### **Meadowbank 2021 Annual Open Pit Geomechanical Inspection**

March 2, 2022

**RE: Meadowbank Complex - Meadowbank Site - 2021 Annual Open Pit Geomechanical Inspection**

## B Dump - Lower Dump Platform

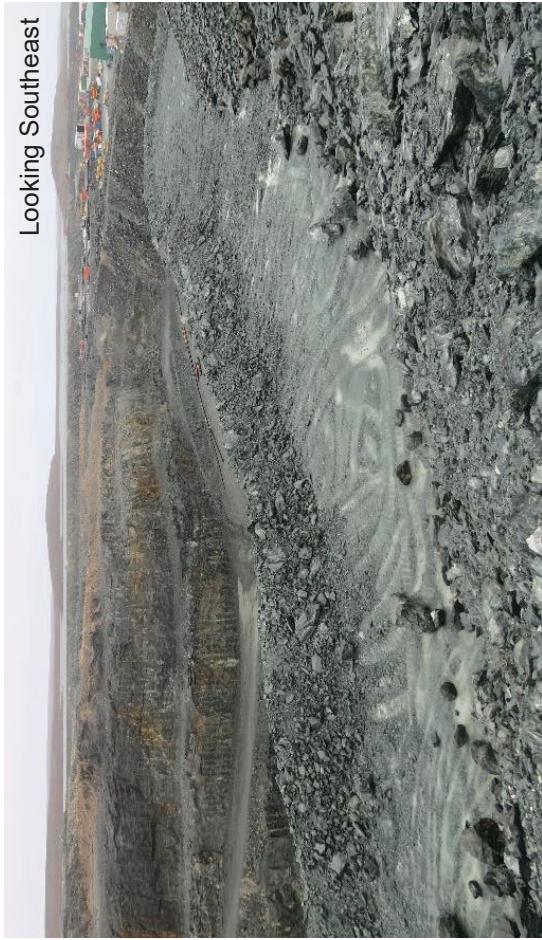
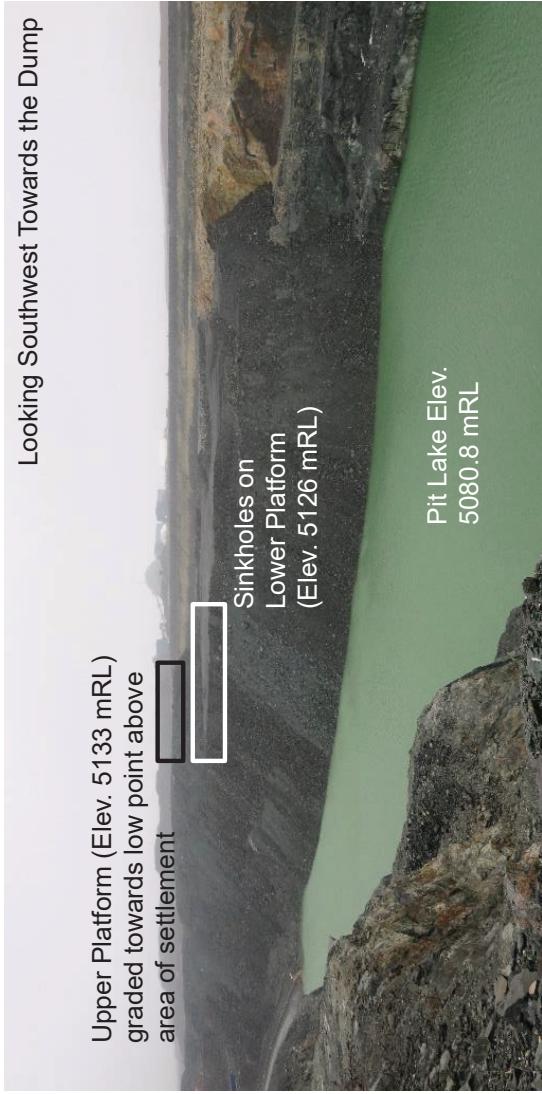
- Based on discussions with C. Clayton and C. Tremblay, there has been little change in the sinkholes and settlement since the 2020 inspection. No obvious bulging of the toe of the dump slope was observed. It was noted that the deposition of Ultramafics within the dump had previously contributed to settlement of the dump.
- Continue to monitor the settlement and tension cracks at the north end of the dump. Recommend surveying the cracks so that their development over time can be monitored.
- Recommend grading the Lower Platform prior to the winter in order to limit water infiltration during freshet.

Sinkholes at South End of Lower Platform  
(Looking South)

Settlement and Tension Cracks at North End of Lower Platform  
(Looking South)

## C Dump

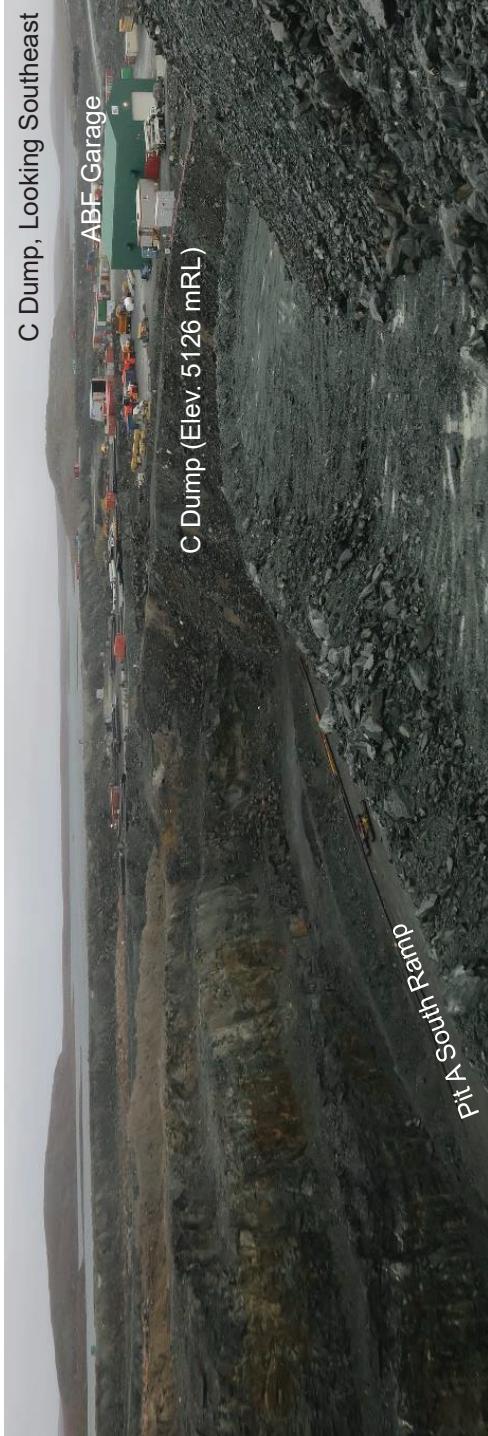
- The C Dump backfilled Pit C and is located between Pits A and E and is inactive. Access to the dump platform is permitted.
- The ABF Garage was constructed on the C Dump platform in 2020, approximately 35 to 45 m from the crest of the dump. As the water elevation in Pit A and the water/tailings elevation in Pit E reach and surpass the base of the dump, settlement of the dump is expected.

- The associated geotechnical risks for the garage were discussed in detail in the 2020 inspection report. The recommendations from that report remain applicable. It is recommended that the garage be relocated outside of the immediate vicinity of the open pits, waste dumps and tailings/water management areas and that access to the C Dump be prevented with a berm.

- Note that the 2020 inspection report identified a water/tailings elevation of 85 masl as a possible threshold for migration of water below the C Dump. The water elevation in Pit A at the time of the 2021 inspection was just under 81 masl. No evidence of instability was observed at the time of the 2021 inspection.

## D Dump

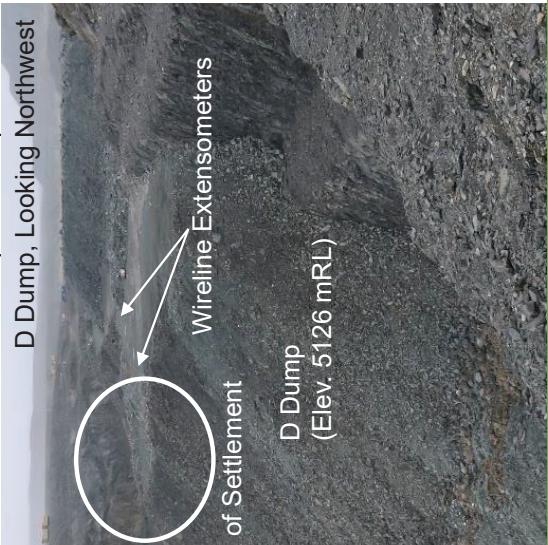
- The D Dump backfilled Pit D and forms the north wall of Pit E. The Pit E Northwest ramp runs along the western toe of the dump.
- The southwestern end of the dump started to settle in 2017 to 2018. Tension cracks are visible in this area as well as along the crest immediately to the north. It is understood that there has been limited change in the settlement or tension cracks since the 2020 inspection. Bulging of the toe of the slump was not observed. Access to the top of the dump is restricted by a berm.

- Two wirelines extensometers have been installed at the crest of the dump in the area of settlement and tensions cracks in 2019. The extensometers are monitored monthly. The data are discussed later in this presentation but the deformation rate is currently less than 1mm/day. The monitoring and the monthly visual inspections should continue while access to the Pit E Northwest ramp is still required.

## Pit E - Northwest Wall and Ramp (Potential Hazards)

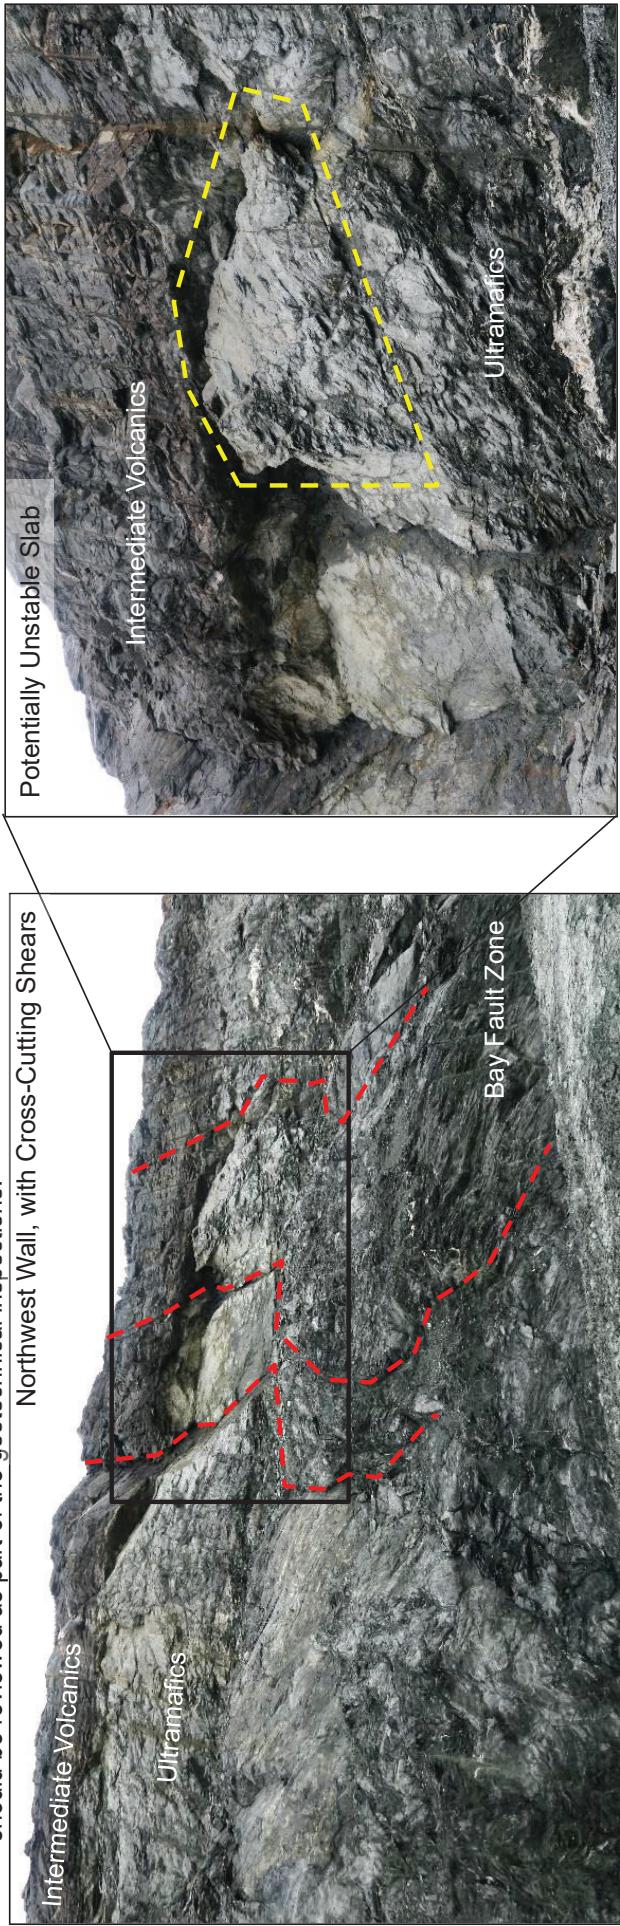
- The nose in the Northwest Wall is intersected by the Bay Fault. The zone of reduced rock mass quality associated with the fault has ravelled over time, resulting in rockfall.
- A block was identified at the crest of the bench that represents a rockfall hazard. The block is expected to be retained by the rockfall berms.

- A large detached and potentially unstable block was identified on the southern side of the nose during the 2020 inspection.
- The block has the potential to overtop the rockfall berm and should continue to be monitored.

## Vault Open Pit - General

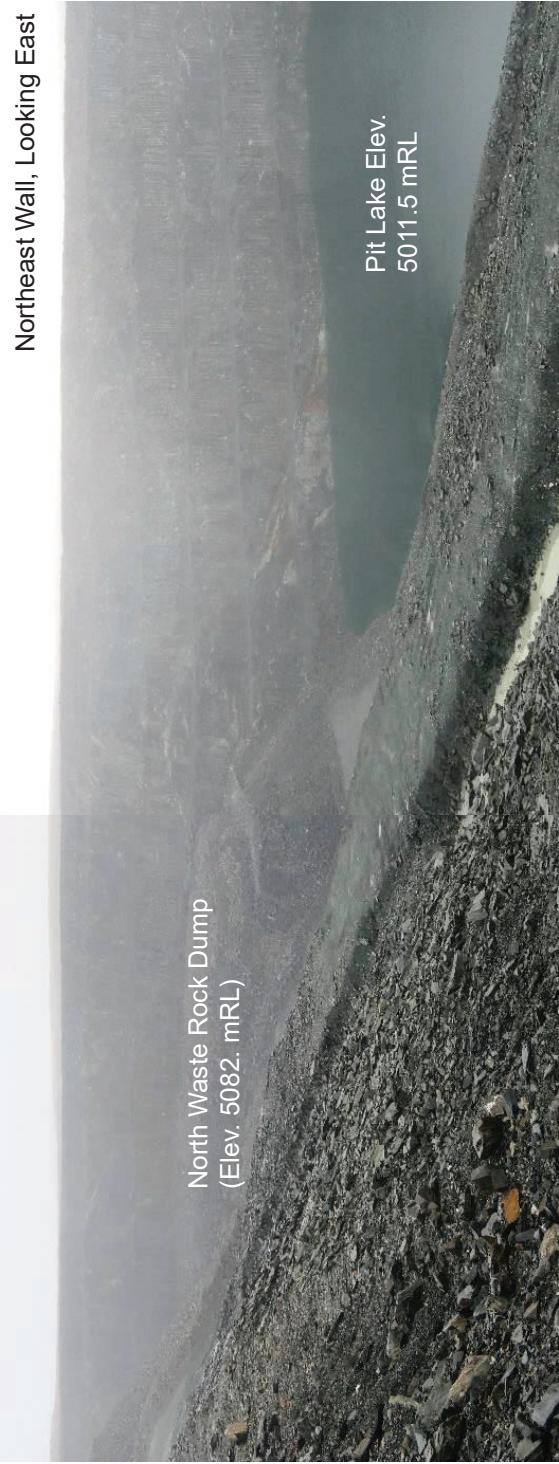
- Access to the open pit is limited to monthly water quality sampling when the pit lake is not frozen.
- At the time of the inspection, access to the open pit was prevented by a berm. Access to the ring road is partially restricted by a berm at the north end of the road. The berms are shown in yellow at right.

- The open pit is partially flooded. The elevation of the pit lake was last measured in September, 2020 when it was 5011.5 mRL.
- The Amaruq All Weather Road (AWR) crosses between the Vault and Phaser Pits on a rockfill embankment.

## Vault Open Pit - Southwest Wall

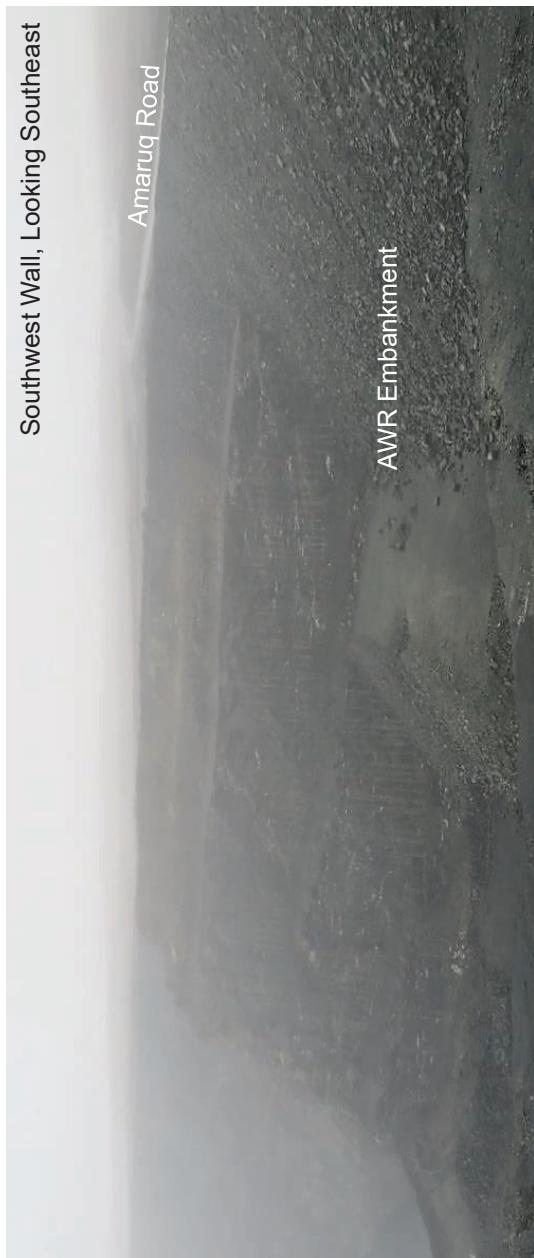
- The Amaruq AWR crosses a saddle between the Vault and Phaser pits on a rockfill embankment.
- No evidence of instability in the AWR embankment was observed. No tension cracks on the surface of the road or bulging of the embankment toe were noted. The embankment is included in the geotechnical inspections.
- The stability of the Amaruq AWR embankment could be adversely impacted if the water level in the Phaser Pit on the other side of the embankment increases and water ponds behind the embankment. No seepage was observed at the time of the inspection. The presence of seepage should be evaluated as part of the monthly inspections.

## Vault Open Pit - North Waste Rock Dump

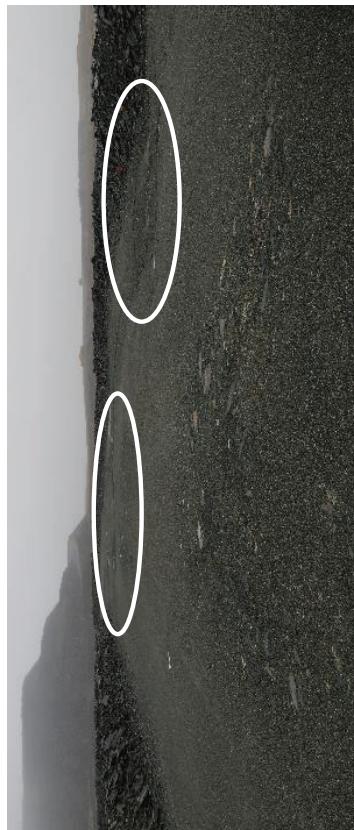
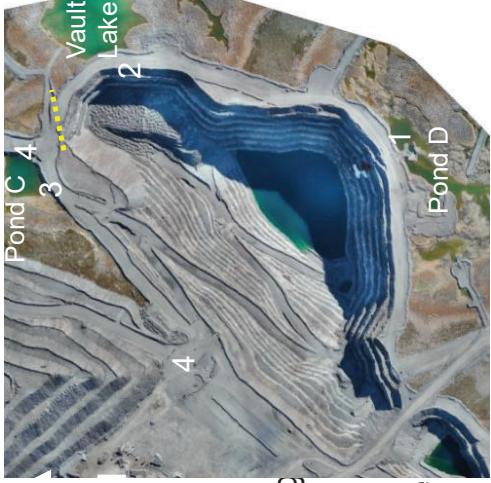
- A waste rock dump was constructed at the north end of the Vault Pit. The dump is inactive and consists of two platforms with elevations at approximately 5133 mRL and 5082 mRL.
- Settlement and tension cracks were observed at the crest of the upper platform at the north end of dump during the 2019 inspection. There appears to have been little change since that time. The affected area is relatively small and is not above the ramp. Consider including this area in the monthly visual inspections.
- No other evidence of instability was observed during the inspection.
- Access to the dump was not restricted at the time of the inspection. Recommend installing a berm to prevent access as the dump is inactive.

## Phaser and BB Phaser Pits - General

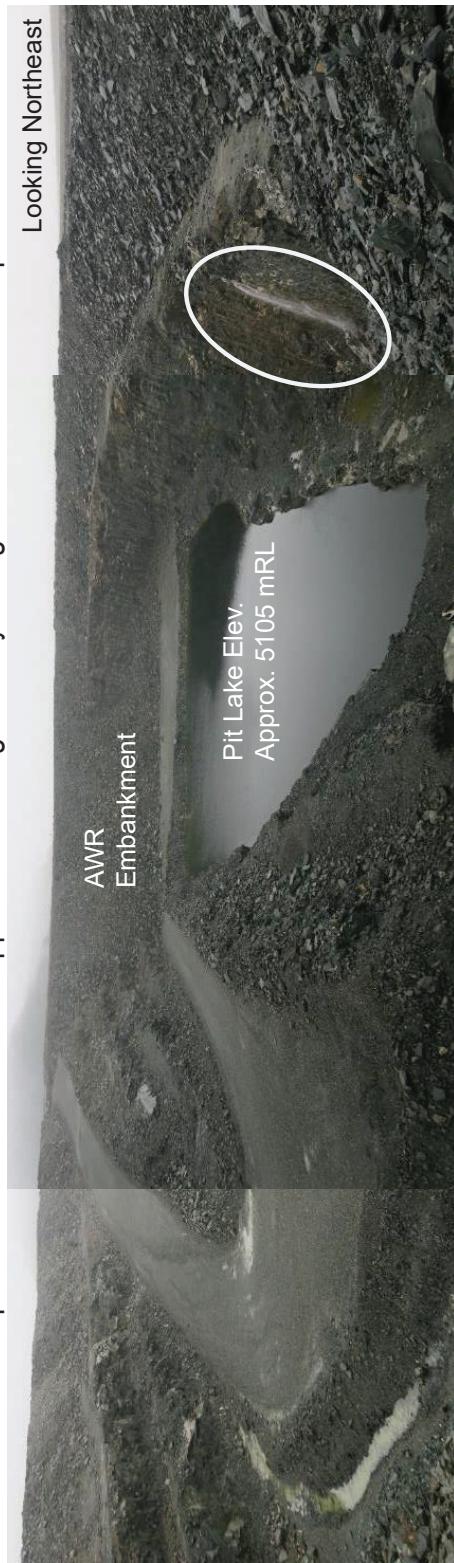
- Access to the open pits is limited to monthly water quality sampling when the pit lake is not frozen.
- At the time of the inspection, the accesses to the open pits were barricaded by berms (shown as dashed lines at right).

- Note that the Amarug All Weather Road (AWR) crosses between the Vault and Phaser Pits on a rockfill embankment.
- The potential for approaching the WSCC about ending the third party inspections for both the Phaser and BB Phaser open pits was discussed as the exposed rock slopes and associated hazards are limited. As on-going access to the pits is still required for water quality sampling, AEM should complete internal visual inspections prior to the sampling events. Similarly, the monthly inspections of the AWR should continue.

## Inspections

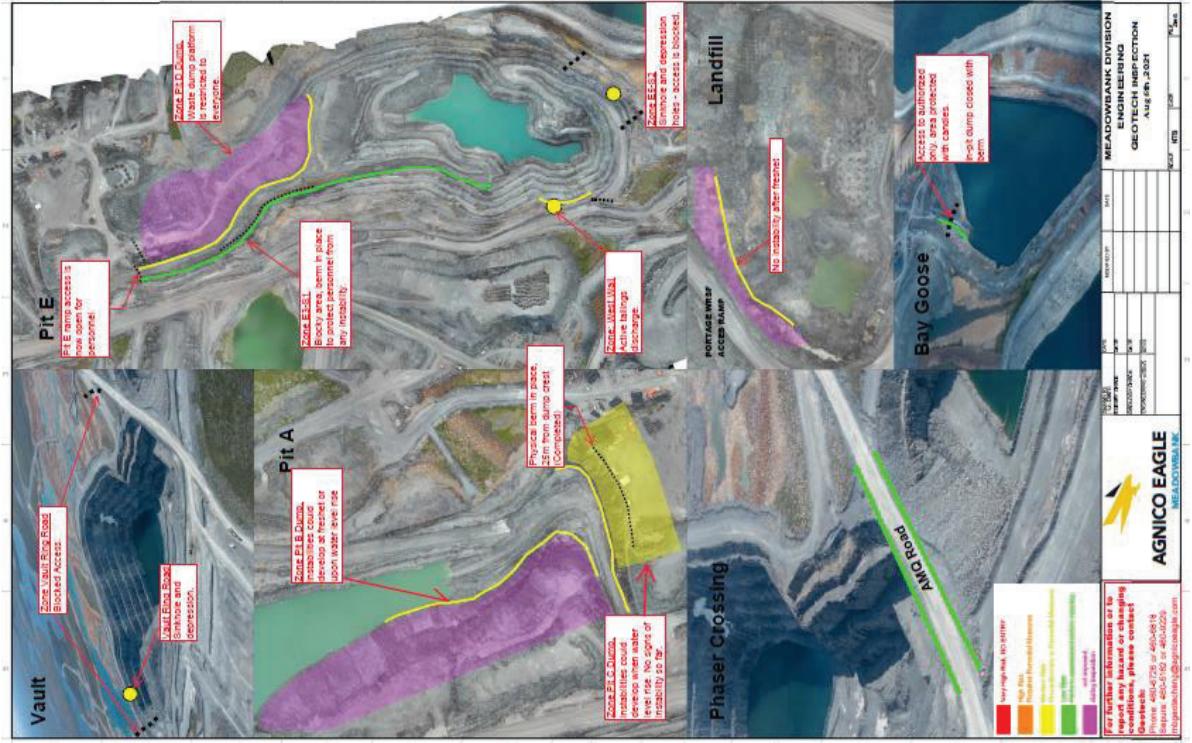
- Visual inspections are completed by the Geotechnical Group on a monthly basis and a summary report and map issued.
- The Rock Mechanics Group does not currently commit to any inspections of the Meadowbanks pits, though an inspection was completed in August of this year. The mine is fortunate that many members of the Geotechnical Group have open pit rock mechanics experience. However, this could change over time. Recommend implementing an annual inspection of the open pits and in-pit dumps by the Rock Mechanics Group in areas where access is still required.

- A selection of the inspection reports were reviewed and the following discussed:
  - Most of the key hazards identified during the 2021 annual inspection are included in the monthly reports. However, the ramps used to access the pit lakes in the Goose Pit, Portage Pit A, Vault Pit, and Phaser/BB Phaser Pits are not. Recommend including these areas, as well as the Vault Ring Road, in the inspections, at least during periods when access to the ramp is required (e.g., for pump maintenance or water quality sampling).

- The inspections include a series of standard photos from the same positions. This is a good practice as it allows changes to be tracked over time.
  - While the frequency of the visual inspections is reasonable, recommend having a formal mechanism in place to increase the frequency in, for example, the event that an instability is observed. This commonly takes the form of a Trigger Action Response Plan (TARP).

- At least two rockfalls have occurred in Pit E since the 2020 annual inspection. Rockfalls are commented on in the inspection reports but are not tracked in a rockfall database. Recommend recording and reporting (as appropriate) rockfall events that occur within the open pits used for tailings and water management in areas where there is the potential for worker access.

## Instrumentation

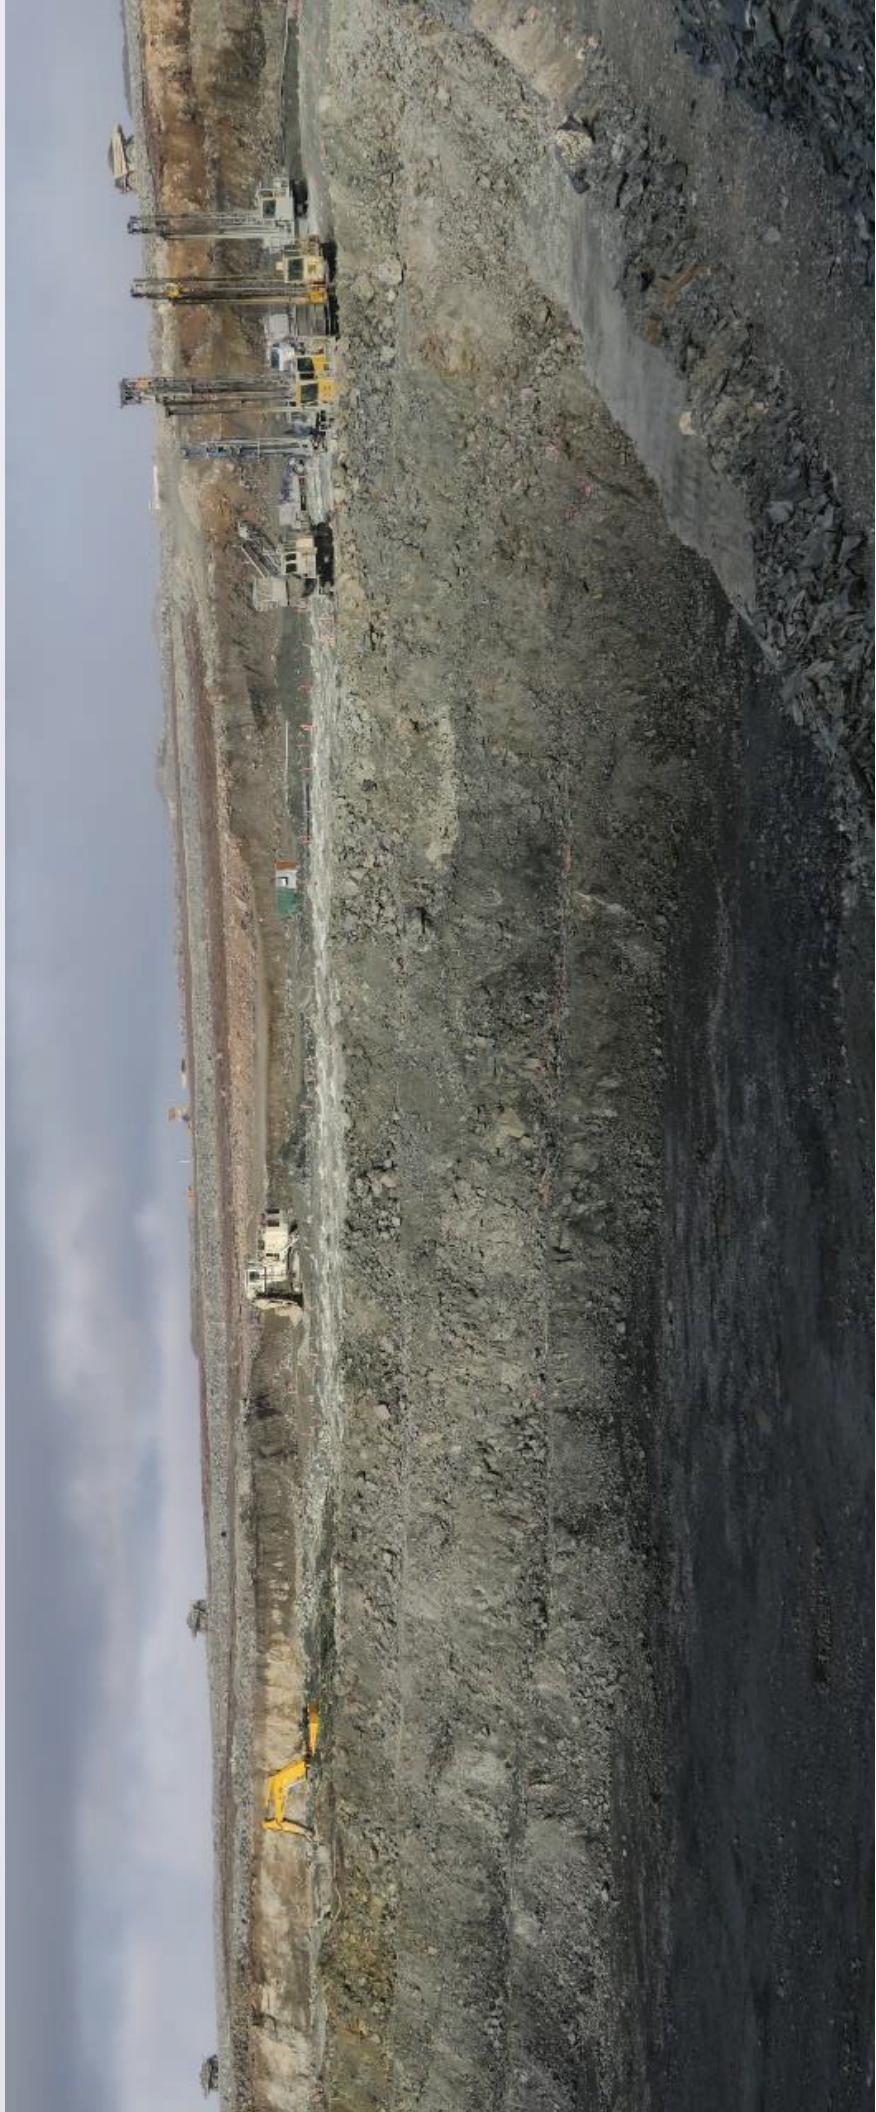
- TDR cables were installed at Pit E and the Goose Pit and an inclinometer was installed at Pit E. These instruments are no longer monitored.
- Wireline extensometers were installed at the crest of Dump D, above the northern ramp into Pit in response to the development of tension cracks on the upper platform of the dump. The Geotechnical Group commit to monitoring the extensometers on a monthly basis, with more frequent readings depending on the observed displacement, as set out in the procedure "Wireline Extensometer Monitoring in Rock Storage Facility". The procedure also defines displacement rate thresholds and the associated responses.

- Monthly readings for the extensometers are available since June, 2021 although both were reset in July. The data are shown above. Extensometer 2 is reporting displacement, though the current rate of <1 mm/day is much less than the 50 mm/day threshold that would trigger a response under the procedure. Monitoring of the extensometers should continue.

- The extensometers provide point measurements of displacement and are limited to Dump D. Settlement and tension cracks have been observed at most of the in-pit dumps. Recommend evaluating the use of the drone survey imagery and photogrammetry to evaluate settlement across all of the dumps on an annual basis. This would provide a more comprehensive solution without the need for an extensive network of instruments.
